**PLANNED UNIT DEVELOPMENT
STAFF REPORT****Date: June 4, 2015****DEVELOPMENT NAME**

Sunbelt Rentals, Inc.

LOCATION5909 Rangeline Road
(Northeast corner of Rangeline Road and Abigail Drive)**CITY COUNCIL
DISTRICT**

Planned Unit Development Approval to amend a previously approved Planned Unit Development to allow multiple buildings on a single building site with an additional access.

SITE PLAN

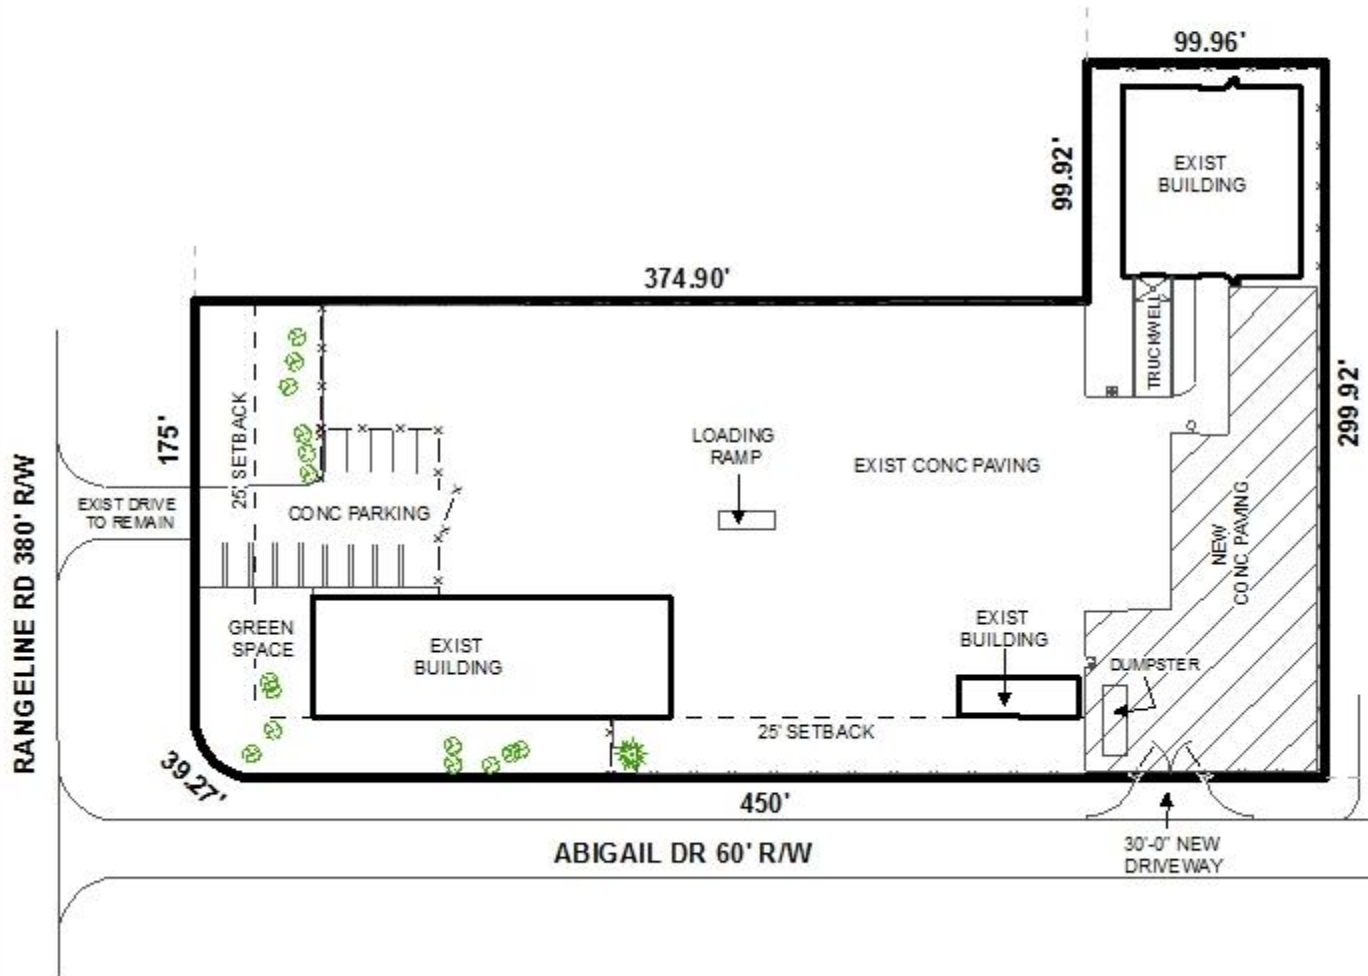
The site plan indicates the site as originally approved with very minor differences, primarily the location of a dumpster and some trees, and the proposed new access. The proposed drive to Abigail Drive is indicated to be 30' wide to allow for truck and equipment egress from the site. It should be noted that the Subdivision associated with the previous PUD was conditioned upon the placement of a note on the Final Plat stating that curb cuts be limited to those shown on an approved PUD site plan and not specifically to any number or street frontage. Therefore, no amended Subdivision would be required. And as Abigail Drive is a public street, no other properties would need to be included in this PUD. Therefore, the allowance of the proposed curb cut would seem appropriate, subject to Traffic Engineering approval. As gates are proposed without entry traffic queuing space, and the access is intended for egress only, traffic control signage and/or pavement markings should be placed to indicate one-way egress traffic only.

The site plan indicates only eight frontage trees for the entire site, all along Abigail Drive. Other trees are indicated, but beyond the frontage setback. As the original site plan also indicated frontage trees along Rangeline Road within the setback, and the PUD was approved with a condition of the provision of trees / landscaping in compliance with I-1 standards for frontage trees, the site plan should be revised to provide all required frontage trees within the setback. The site plan also indicates an exposed relocated existing dumpster whereas the originally-approved PUD indicated one with enclosure. Therefore, the site plan should be revised to indicate the dumpster in compliance with Section 64-4.D.9. of the Zoning Ordinance.

- 1) revision of the site plan to indicate traffic control signage and/or pavement markings limiting the Abigail Drive access to one-way egress traffic only;

- 2) revision of the site plan to provide the required frontage trees within the setback along Rangeline Road and Abigail Drive;
- 3) revision of the site plan to indicate the dumpster in compliance with Section 64-4.D.9. of the Zoning Ordinance;

- 4) placement of a note on the site plan stating that any new lighting must comply with Sections 64-4.A.2., 64-6.A.3.c. and 64-6.A.8. of the Zoning Ordinance;
